Reply to: Interactive comment on GO2OGS: a  
versatile workflow to integrate complex geological  
information with fault data into numerical  
simulation models  
Anonymous Referee #1

T. Fischer et al.

October 12, 2015

Figure 1: Workflow of GO2OGS for GOCAD to OGS mesh conversion; “Setup A” shows a model of different sedimentary layers; “Setup B” shows a model of the Thuringian Syncline (legend given in Fig. ??); see Sect. ?? for description of setups.

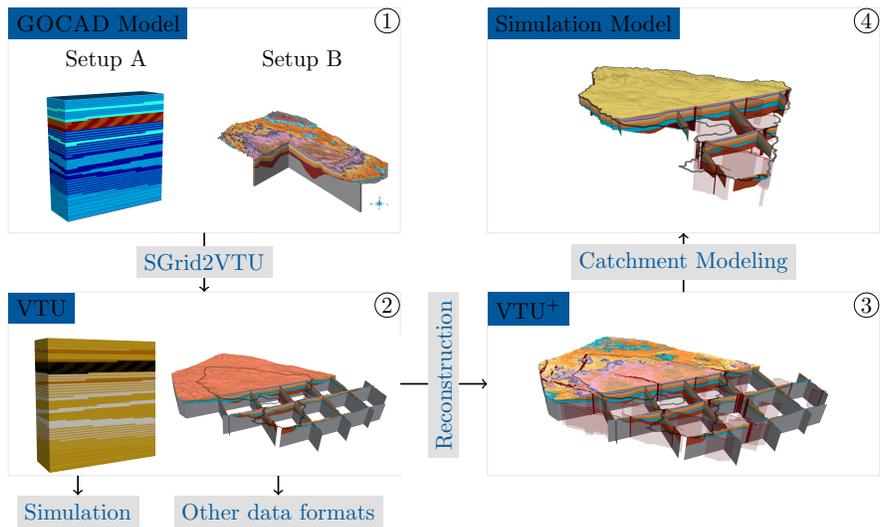
**2.17 Figures: Fig. 2: Reconstruct = Reconstruction**

Changed word in the figure. See Fig. 1 of **this** document.

Figure 2: Mesh elements at non-continuous geological units, vertical cross section *A–B* (see Fig. ??) through GOCAD model at different magnification levels, vertical exaggeration 20×, legend given in Fig. ?? .

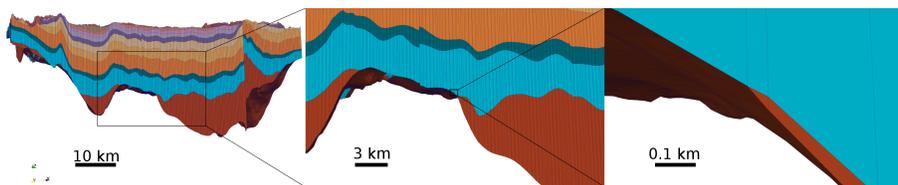
**2.20 Fig. 5: Scale and orientation are missing**

The location and orientation of the fault within the study domain is given in Fig. 1.

We added length scales within the sub-figures (see Fig. 2 of this document).

Figure 3: Histogram of aspect ratio classes for read GOCAD SGrid mesh data (gray) and reconstructed mesh data (green), sample elements for selected aspect ratios.

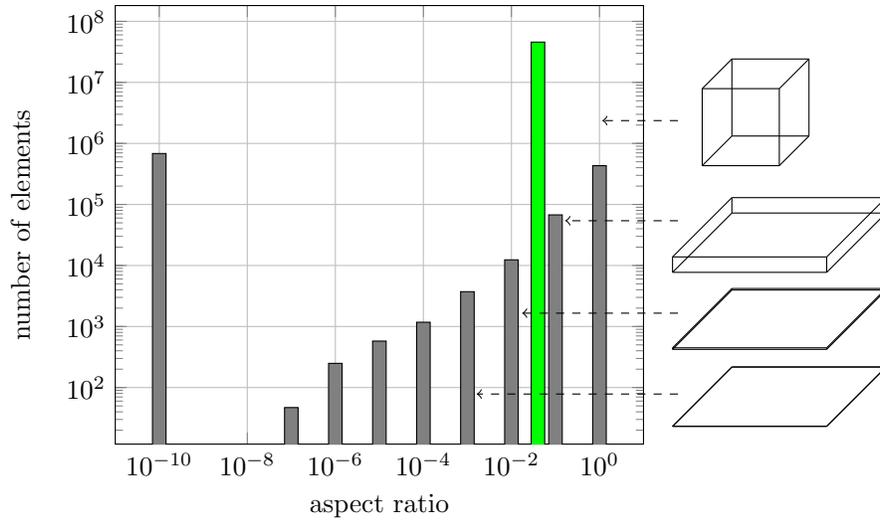
**2.21 Fig. 6: There are colors on the right-hand side figures but no colored bars?**

We changed the colours of the example element at the right side to omit confusion, see Fig. 3 of this document.

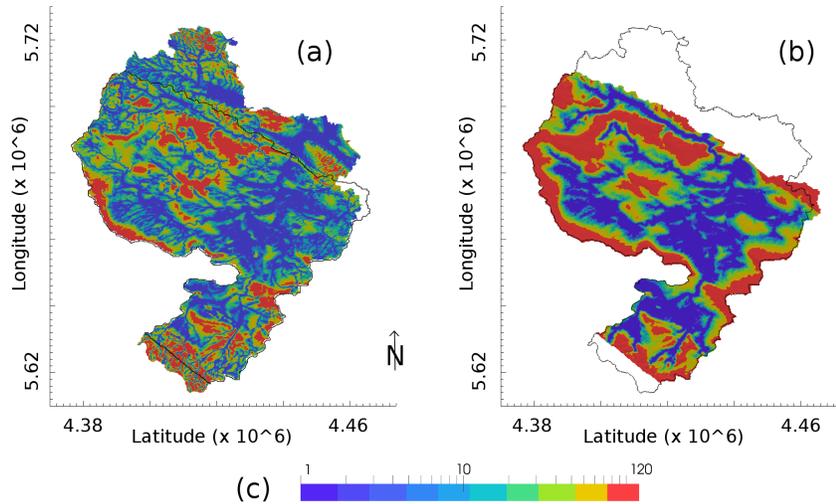
**2.24 Fig. 9: Increase readability of axes!**

We improved the readability of the axes, see Fig. 4.

Figure 5: Detail of flow paths near faults and bottleneck structure, pathlines colored by elevation; area shown in Fig. ??: **(a)** heterogeneous simulation S1, **(b)** homogeneous simulation S2.

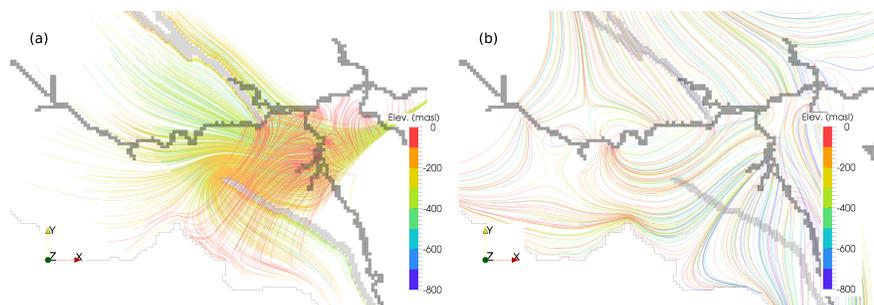
**2.25 Fig. 11: Increase resolution and readability of axes!**

We increased readability of the axes (see Fig. 5).
